FERC Docket No. P-77-332

Re: Application for surrender of license and non-project use of project lands (Pacific Gas & Electric Co.; Potter Valley Hydroelectric Project No. P-77): Comments of Friends of the Eel River, Sierra Club, Native Fish Society, Save California Salmon, California Sportfishing Protection Alliance, and Northern California Council, Fly Fishers International

**Figure 1**

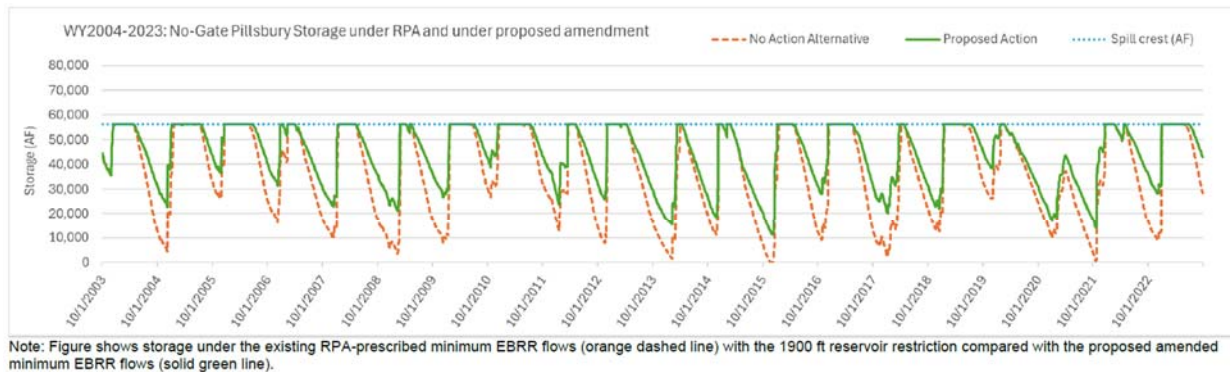
The annual variances and the Non-Capacity License Amendments are necessary, as PG&E has explained, because it cannot meet the RPA flow requirements in most years and avoid endangering ESA-listed steelhead. Figure 1 is from PG&E's January 2025 *Application for Non-Capacity License Amendment* submission to FERC, where it appeared as Fig 3-1.<sup>44</sup> The green line is the flows proposed under the license amendment. The dashed orange line shows the flows now required under the RPA.

The graphic shows that reduced Lake Pillsbury reservoir storage increases the risk of irreparable damage to PVP infrastructure. With current usable storage levels, the PVP could not have met RPA flows in thirteen of the last twenty years without dropping the reservoir below PG&E’s 12,000 acre foot “warning” level. In six years, the 5,000 acre foot “critical” level would have been exceeded.

Similarly, Figure 1 illuminates the problem PG&E confronts in managing the Lake Pillsbury reservoir to protect a cold water pool through the summer, a critical measure to avoid harm to ESA-listed steelhead. By contrast to the flows proposed in the Non-Capacity License Amendment, the RPA flows occur earlier in the season and take a larger portion of storage. Both factors reduce and mix the cold water component of the reservoir pool, resulting in high temperatures in both the reservoir and the upper mainstem below Scott Dam.

Map 2 – Potential barriers and additional habitat in the mainstem Eel River drainage.

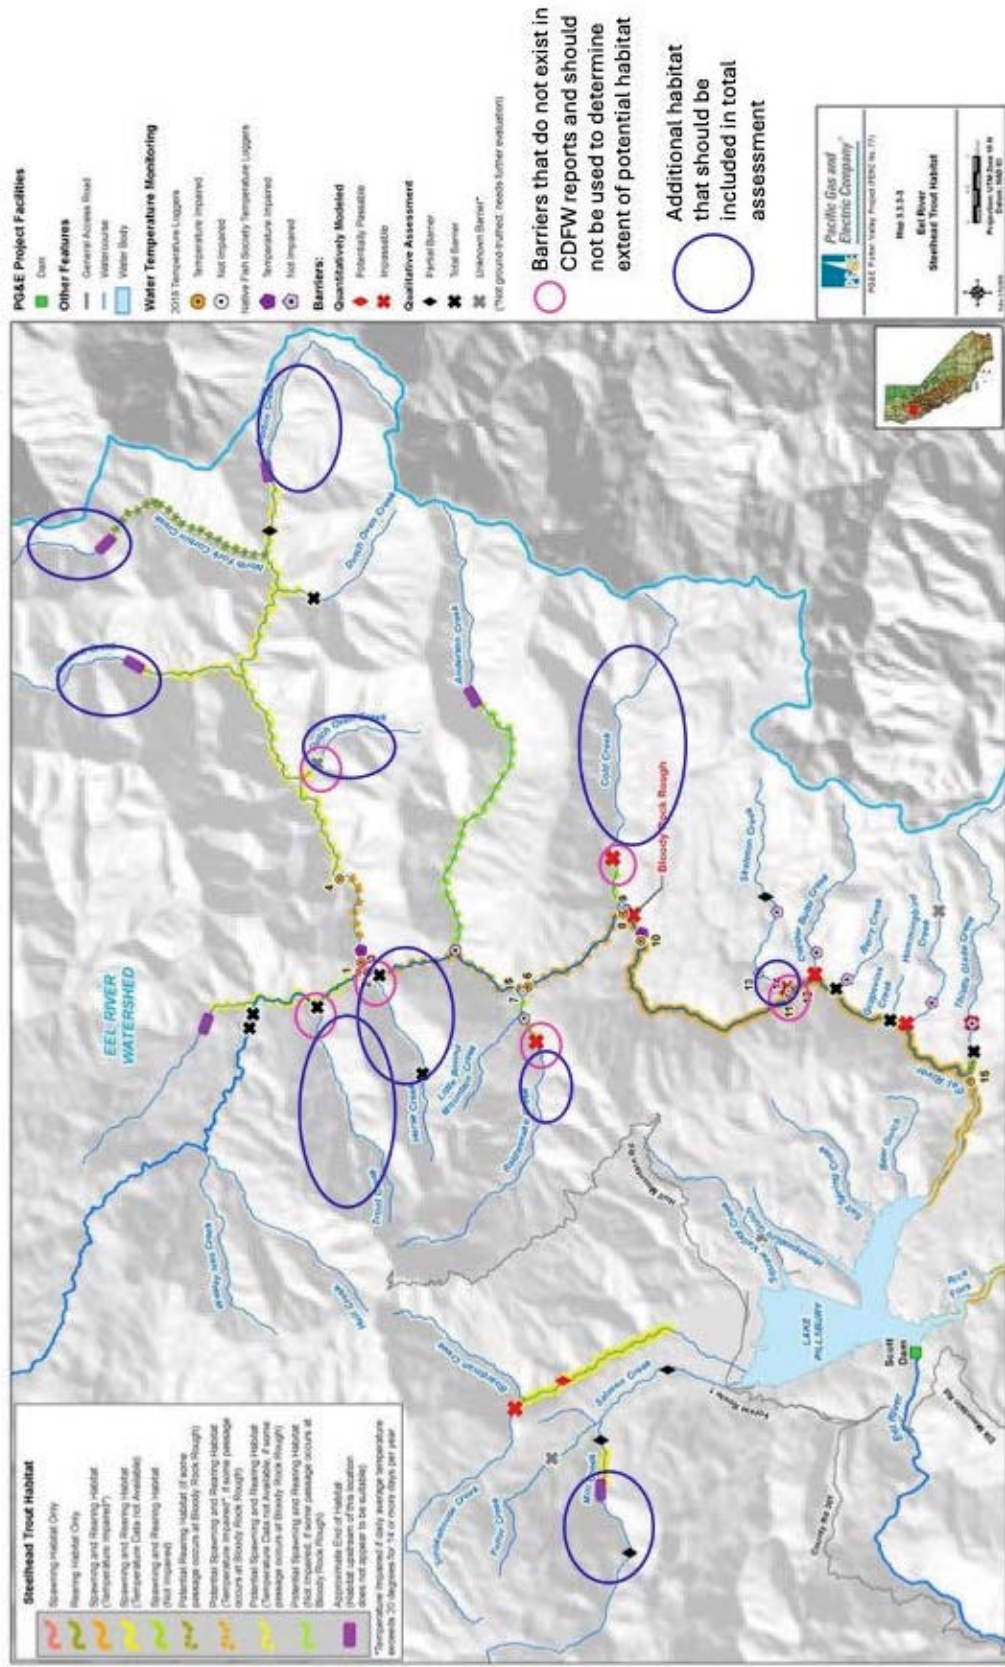
In the comments on the Draft LSA attached as Exhibit A, the Free The Eel Coalition included two maps (modifications of PG&E's maps from the Draft LSA) that summarize the available information about the accessibility of habitat, especially for steelhead, above Scott Dam.<sup>74</sup> Fisheries experts<sup>75</sup> have concurred, based on their assessment of Bloody Rock Roughs, and observations of anadromous steelhead upstream of far more significant barriers in similar watersheds (Van Duzen, Middle Fork Eel, Mad River), that Bloody Rock Roughs is most likely passable at flows that would occur on an annual basis. Designation of Bloody Rock Roughs as an impassible barrier in the draft and final LSAs is based on quantitative model results, according to the legend on Map 2.2.3.3-3,<sup>76</sup> and there appears to have been no ground-truthing of this finding.
